**PLANNED UNIT DEVELOPMENT &
SUBDIVISION STAFF REPORT****Date: August 18, 2005**

<u>DEVELOPMENT NAME</u>	Legacy Shopping Center
<u>SUBDIVISION NAME</u>	Legacy Shopping Center Subdivision
<u>LOCATION</u>	West side of DuRhu Drive, 235'± North of Dauphin Street.
<u>CITY COUNCIL DISTRICT</u>	District 7
<u>PRESENT ZONING</u>	B-2, Neighborhood Business
<u>AREA OF PROPERTY</u>	9.4± Acres
<u>CONTEMPLATED USE</u>	Multiple buildings on a single-building site with shared parking and access.
<u>TIME SCHEDULE FOR DEVELOPMENT</u>	Immediate
<u>ENGINEERING COMMENTS</u>	Must comply with all stormwater and flood control ordinances. Any work performed in the right of way will require a right of way permit.
<u>TRAFFIC ENGINEERING COMMENTS</u>	The attached roadway improvements are proposed and a tentative agreement between the City and the developer is being negotiated. The shown changes should be completed prior to the opening of the development. Driveway number, sizes, location and design to be approved by Traffic Engineering and conform to AASHTO standards. Minimum required widths for driveways with two-way traffic and separate right and left turn lanes are thirty-six feet. The minimum width for a

SITE PLAN

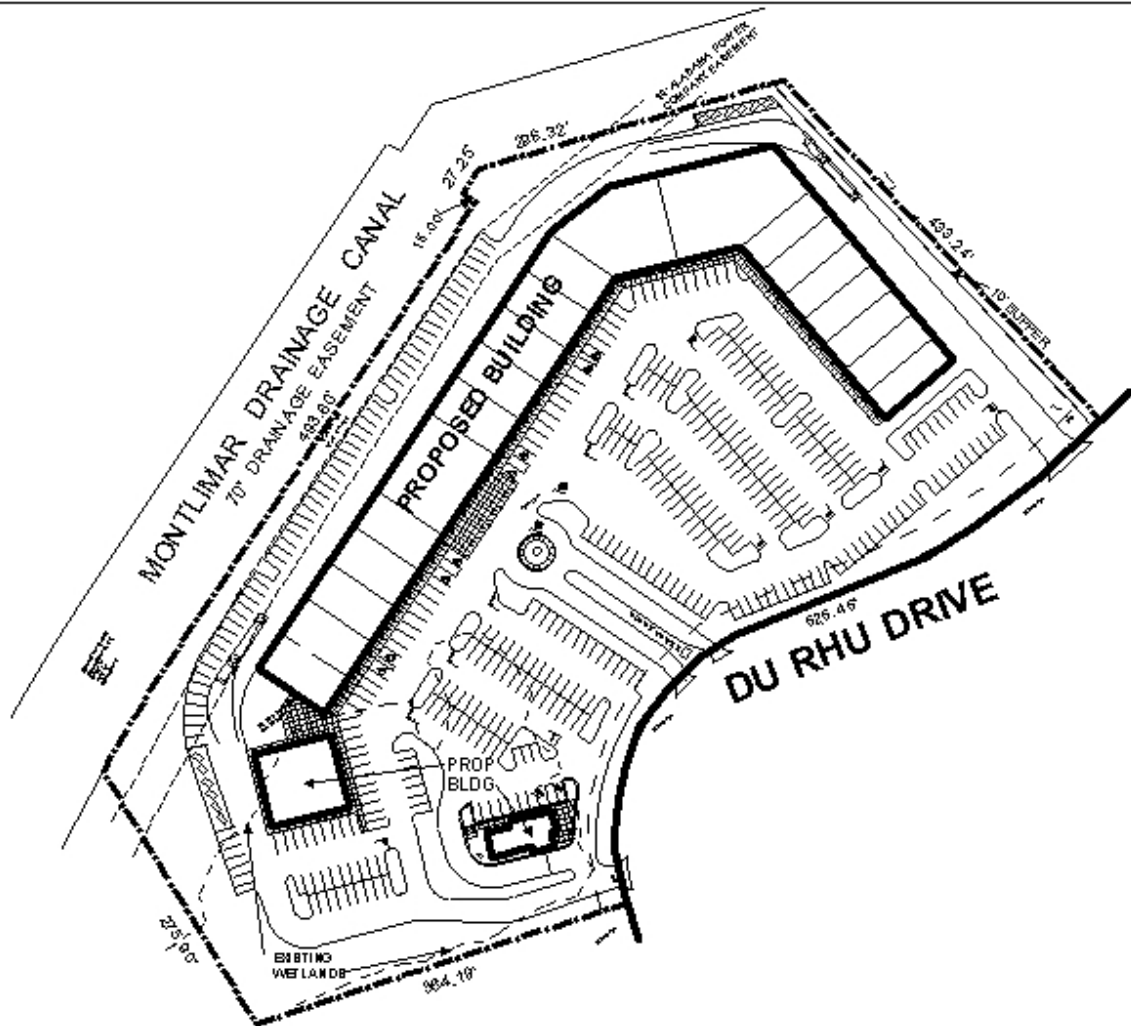
Access to the site will be via a boulevard entrance near the center of the site, and two-way drives located at each end of the site. Comments from the Traffic Engineering Department indicate that revisions to these drives will be required to meet minimum standards for circulation. These revisions should have no appreciable impact on internal circulation.

Based on calculations provided by the applicant, the plan exceeds minimum requirements with regard to parking and landscaped area requirements. The plan, however, does not provide information on tree plantings. Full compliance with the tree planting requirements of the Zoning Ordinance will be required.

Additionally, the site plan does not indicate the location of a stormwater detention basin, which will be required for the site due to the new construction. Conversations with the Engineering Department indicate that the applicant is working to accommodate the city requirements.

RECOMMENDATION **PUD:** Based on the preceding, it is recommended that this application be approved subject to the following conditions: 1) proposed improvements as referenced in the Dauphin Street at DuRhu Drive Traffic Study be completed prior to the issuance of any CO's for the project; 2) Minimum required widths for driveways with two-way traffic and separate right and left turn lanes are thirty-six feet. The minimum width for a one-way drive with separate right and left turn lanes is twenty-four feet. Changes should be made in the existing driveways to accommodate these minimums. All one-way traffic circulation and turn lanes should be signed and marked according to MUTCD standards; 3) provision of a 6' (minimum) privacy fence where the site is adjacent to residentially zoned or developed properties; and 4) full compliance with all municipal codes and ordinances, including but not limited to landscaping and tree plantings, and provision of sidewalks.

SUBDIVISION: The plat meets the minimum requirements of the Subdivision Regulations and is recommended for Tentative Approval subject to the following conditions: 1) proposed improvements as referenced in the Dauphin Street at DuRhu Drive Traffic Study be completed prior to the issuance of any CO's for the project; 2) size, location and design of curb cuts to be approved by Traffic Engineering and conform to AASHTO standards; 3) provision of a buffer in compliance with Section V.A.7 of the Subdivision Regulations; and 4) provision of sidewalks along public street frontage.
